Access Compliance Report

Public Rights-of-Way

(Curb Ramps)

Intersection ID: N/A	Main Street: MELROSE_COTTAGE_DR	Cross Street: MARGARET_WALLACE_RD	Location: N
ADA ID: 282460BE3848	Ramp Type: PerpDiag	Initial Pass/Fail: Fail	Overall Compliance: No
Codes/Mitigation Info/Possible Solution		Field Measurements/Component Compliance	
Severity Score: 21.25

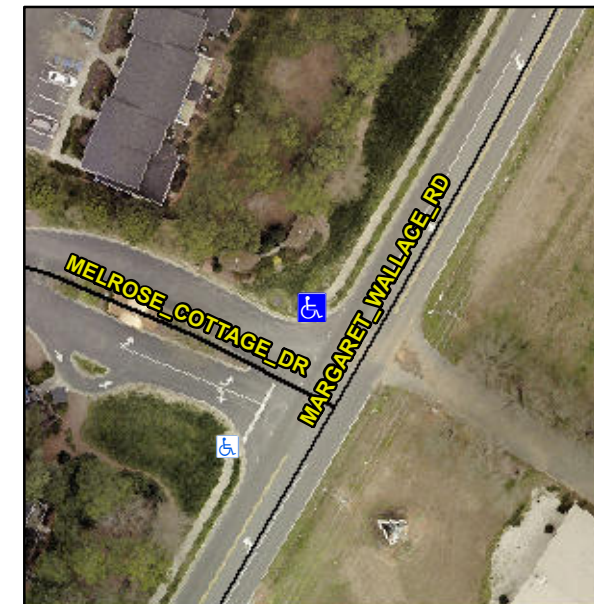
Not Found, R304.5.1, R304.2.2

Compliance	Description	Data	Compliance	Description	Data
N/A	Ramp Length (in)	45.0	No	Ramp Slope (%)	8.7
No	Ramp Width (in)	40.0	Yes	Ramp XSlope (%)	0.1
N/A	Flare Type LT	N/A	N/A	Flare Type RT	N/A
N/A	Flare Slope LT (%)	N/A	N/A	Flare Slope RT (%)	N/A
N/A	Flare Traversable LT?	N/A	N/A	Flare Traversable RT?	N/A
N/A	Landing Length (in)	N/A	N/A	DWS Provided?	N/A
N/A	Landing Width (in)	N/A	N/A	DWS Contrast?	N/A
N/A	Landing Slope (%)	N/A	N/A	DWS Length (in)	N/A
N/A	Landing X Slope (%)	N/A	N/A	DWS Full Width?	N/A
N/A	Landing Curb? (Y/N)	N/A	N/A	DWS Offset (in)	N/A
N/A	Shared Landing?	N/A			
N/A	Gutter Ponding?	N/A	N/A	Gutter Slope (%)	N/A
N/A	Gutter Lip Ht (in)	N/A	N/A	Gutter X Slope (%)	N/A
N/A	Painted X Walk1?	No	N/A	Painted X Walk2?	No
	X Walk 1 Direction	To SW		X Walk 2 Direction	To SE
N/A	X Walk 1 Width (in)	N/A	N/A	X Walk 2 Width (in)	N/A
	X Walk 1 Slope (%)	0.2		X Walk 2 Slope (%)	4.9
	X Walk 1 X Slope (%)	3.2		X Walk 2 X Slope (%)	3.5

Remove & Replace Curb Ramp With Two New Directional Ramps or Equivalent.
